Desmet Tag	Client Tag
PW534E.2/1	19-J-876A
PW534E.2/2	19-J-876B

Description : Enzymatic Dosing Pumps

2018	Name	Day	Scale	Weight	Denomination
SEEPEX. ALL THINGS FLOW	Drawn	cbo	30.05.	1:10	45 kg	dimensional drawing
	Checked	lsh	31.05.	EDP-No. 172723.dwg		Drawing-no. 103-C20/M030-C-720A4

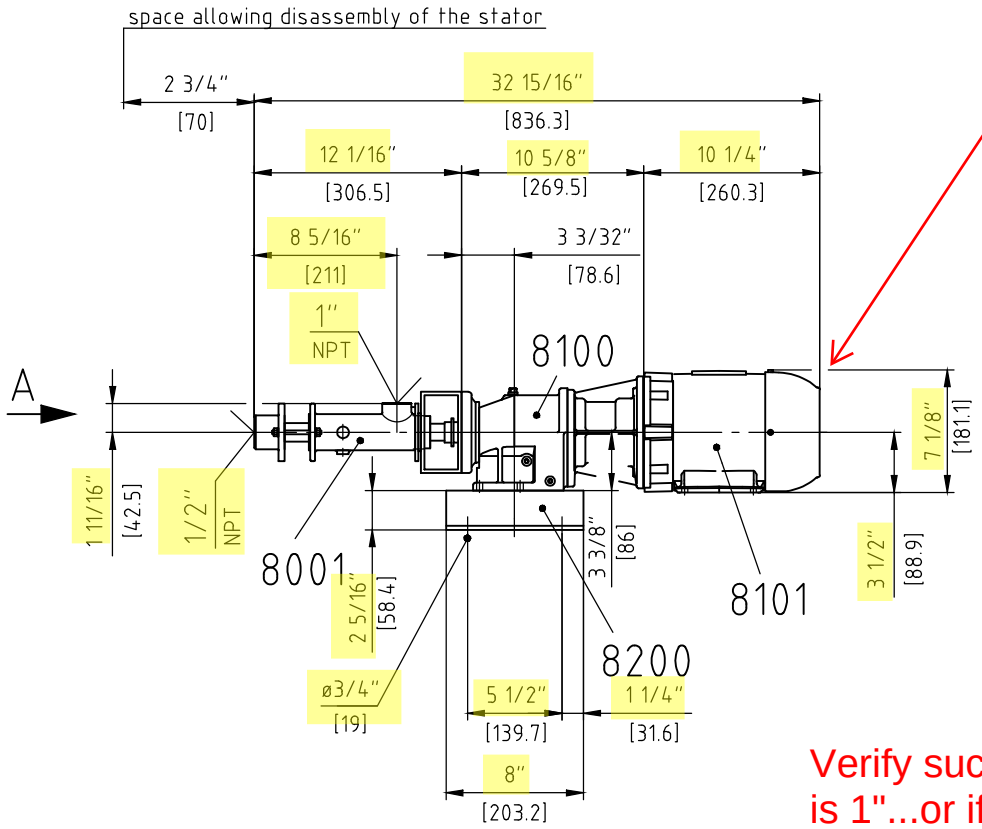
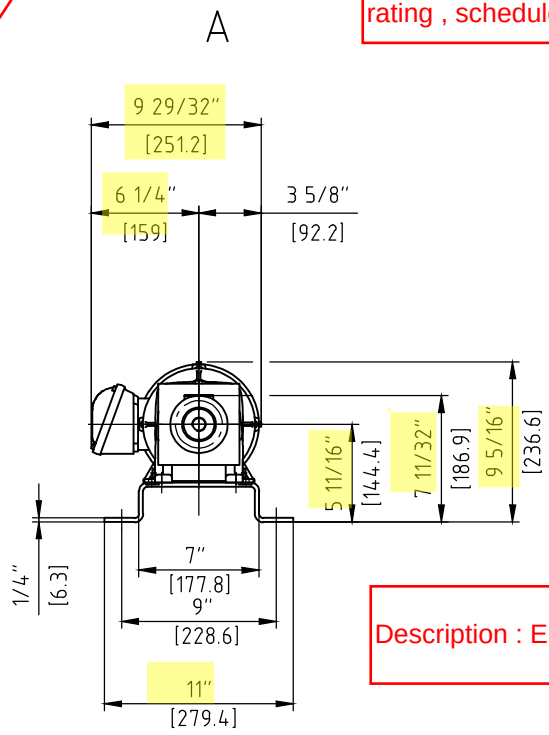
Required Motor and termination box details.

Confirm the following:
1) Motor shall comply with IEEE 841
2) This motor should suitable to operate with VFD

Provide a table for all the nozzles (size , rating , schedule, facing and projection)

Verify suction is 1/2" and discharge is 1"...or if they need to be switched for the end suction arrangement.
